From: Technical Service Department

Date: November 12, 2009

Re: Hairpin Sensor Change on the C6BH-I, B4VM-E and PAH2VM-E

B4VM-E temperature sensor location and C6
sensor location

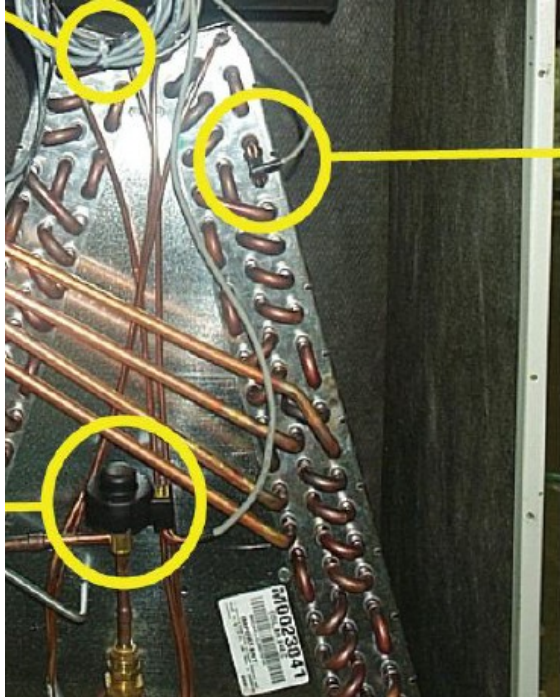
Nordyne is making an improvement to the hairpin sensor located in the iQ evaporator coils (C6BH-I, B4VM-E and PAH2VM-E). The new sensor will be similar to the sensor used on the condensing coil on the iQ Drive Heat Pump.

If the sensor has to be replaced, clip the new sensor in the same location where the old sensor was located (refer to sensor location on page 2) and wrap the new sensor with cork tape or tar tape type material. Wire the sensor terminals to the air handler interface board or furnace VSHE motor board.
